DMC:	342-49-023 – SERVICE BULLETIN
Title:	Introduction of criteria for boroscopic inspection
Issue number:	002
Issue Date:	09-05-2022

This Service Bulletin (SB) is applicable to all APU power plant fitted on Leonardo Helicopters AW189 or AW149 helicopters.

Following the boroscopic inspection (performed for scheduled or unscheduled maintenance), no criteria were given to define at which stage a component is considered as damaged. This Service Bulletin (SB) provide additional instructions to help maintenance operators.

Figure 1 – Air intake casing

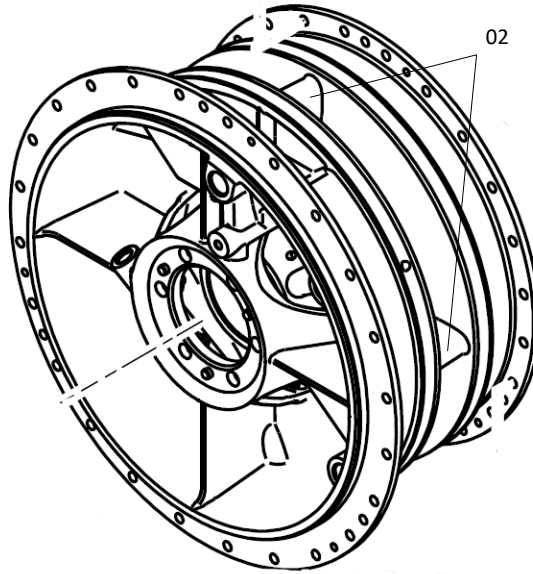
LOC	OBSERVATION	CODE	CRITERIA
02	CRACK(S)	085	NO TOLERANCE

Figure 2 – Compressor wheel

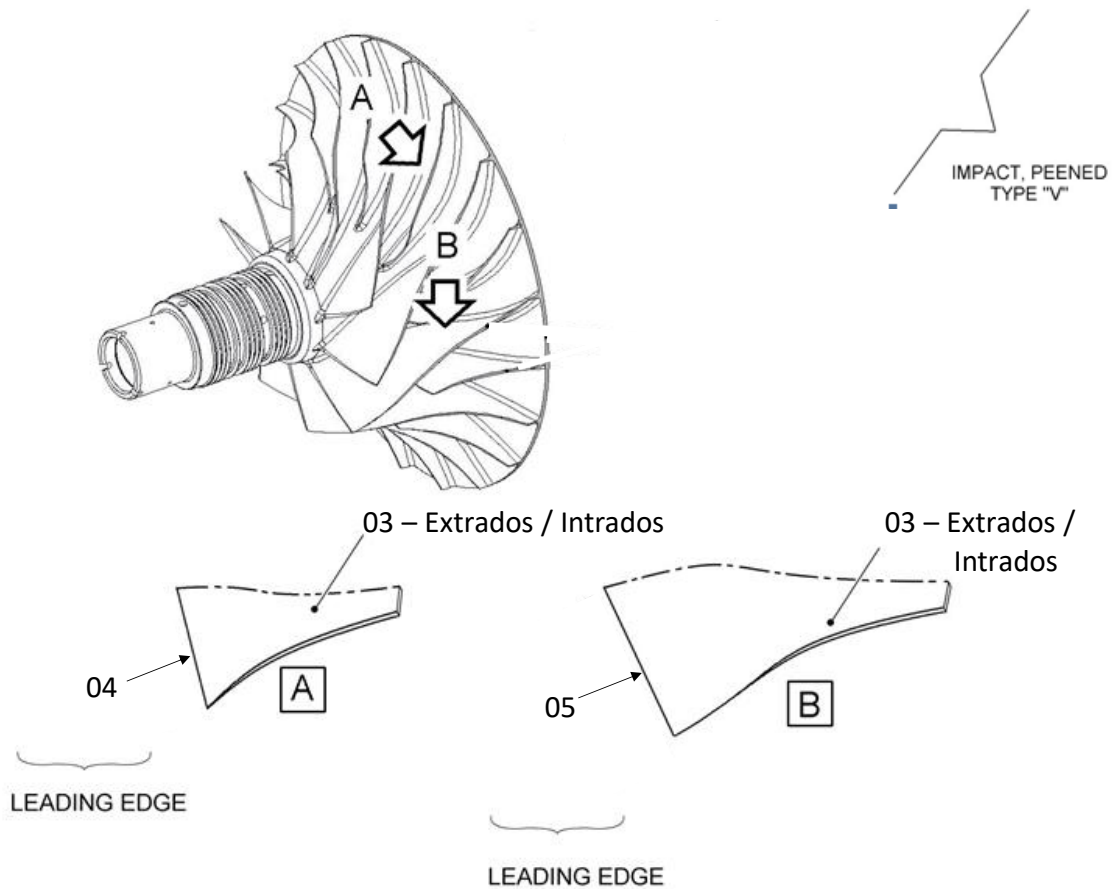
LOC	OBSERVATION	CODE	CRITERIA
01	CRACK(S)	085	NO TOLERANCE
03	IMPACT	099	TYPE V NO TOLERANCE
04	IMPACT	099	TYPE V NO TOLERANCE
05	IMPACT	099	TYPE V NO TOLERANCE

Figure 3 – Combustion chamber

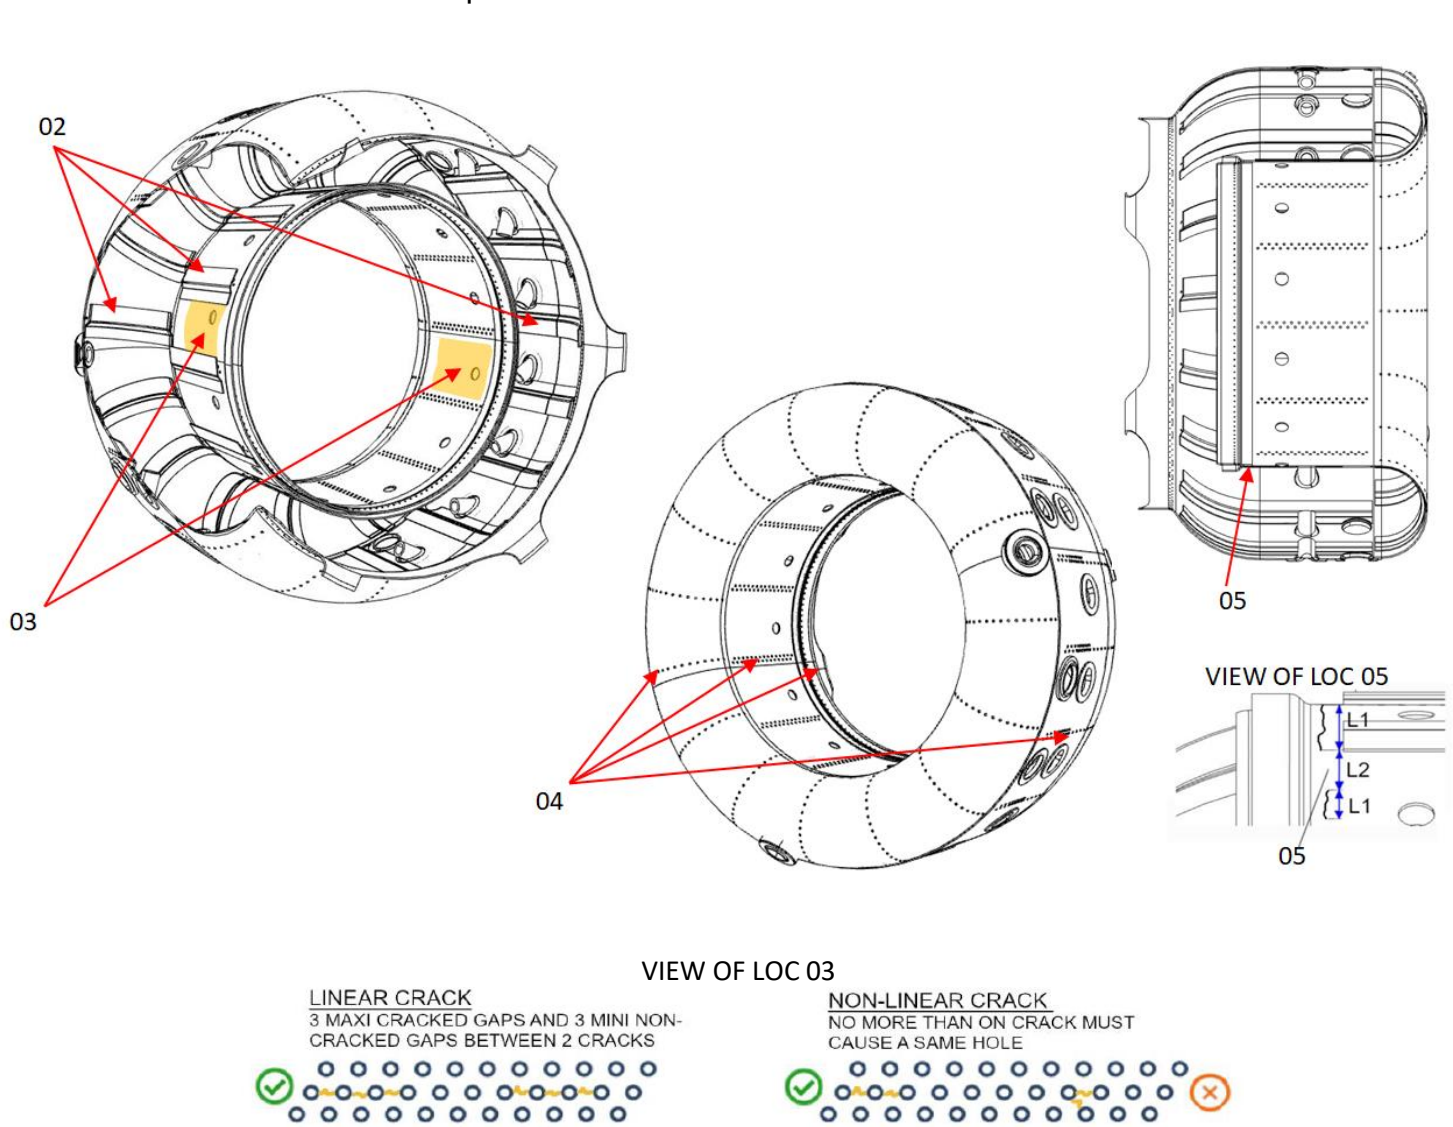
LOC	OBSERVATION	CODE	CRITERIA
01	BURNING	058	COLORATION: ACCEPTABLE
02	BROKEN	052	NO MORE THAN 30% OF LOSS OF MATERIAL ON MAX 3 DEFLECTORS
03	CRACK(S)	085	LENGTH MAX 30MM
04	CRACK(S)	085	- LINEAR CRACK BETWEEN HOLES: 3 MAXI CRACKED GAPS AND 3 MINI NON-CRACKED GAPS BETWEEN 2 CRACKS -NON-LINEAR CRACK: NO MORE THAN ONE CRACK MUST CAUSE A SAME HOLE
05	CRACK(S)	085	LONGITUDINAL: LENGTH (L1) MAX. 50MM ON NO MORE THAN 3 AREAS WITH CLEARANCE BETWEEN CRACKS 20 MM (L2)

NOTA : LOC 01 is applicable to the whole part.

Figure 4 – 2nd stage turbine nozzle

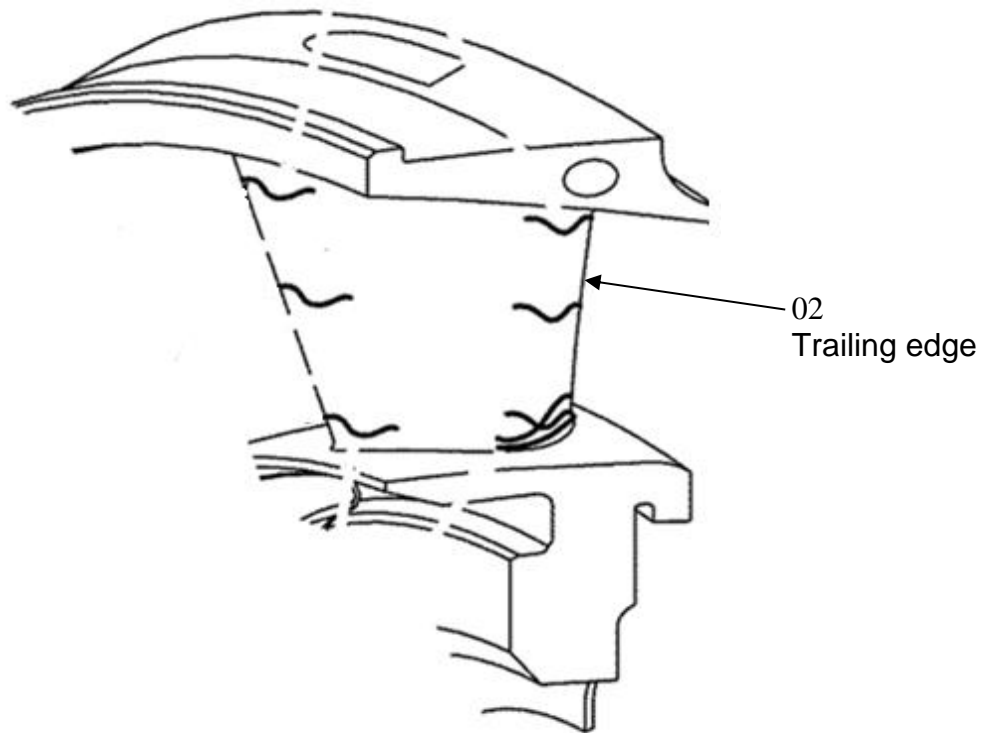
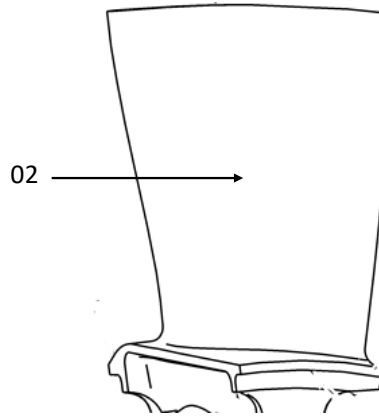
LOC	OBSERVATION	CODE	CRITERIA
02	CRACKS ON TRAILING EDGE	085	NO TOLERANCE

Figure 6 – Exhaust cone arms

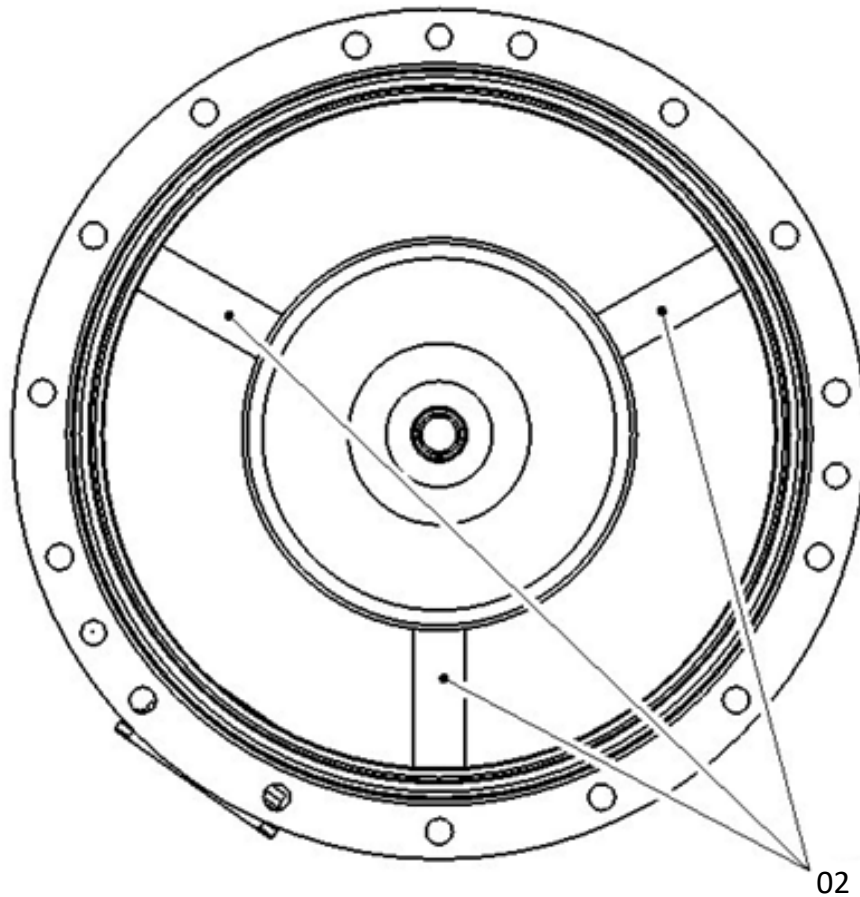
LOC	OBSERVATION	CODE	CRITERIA
02	CRACKS IN WELD SEAM	902	NO TOLERANCE
